REMARKS

The Office Action mailed December 16, 2004 has been carefully considered.

FIG. 3D
(PRIOR ART)

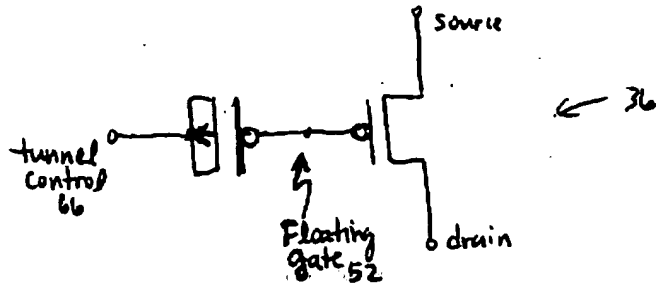
The attached replacement and annotated sheet(s) of drawings include changes to FIGS. 3A – 3D, which have been amended to provide the legend “PRIOR ART.”

The drawing figures have been corrected in accordance with the Examiner's suggestions. Specifically, the legend "PRIOR ART" has been added to FIGS. 3A – 3D. No new matter has been introduced. Approval of the corrections is respectfully requested.
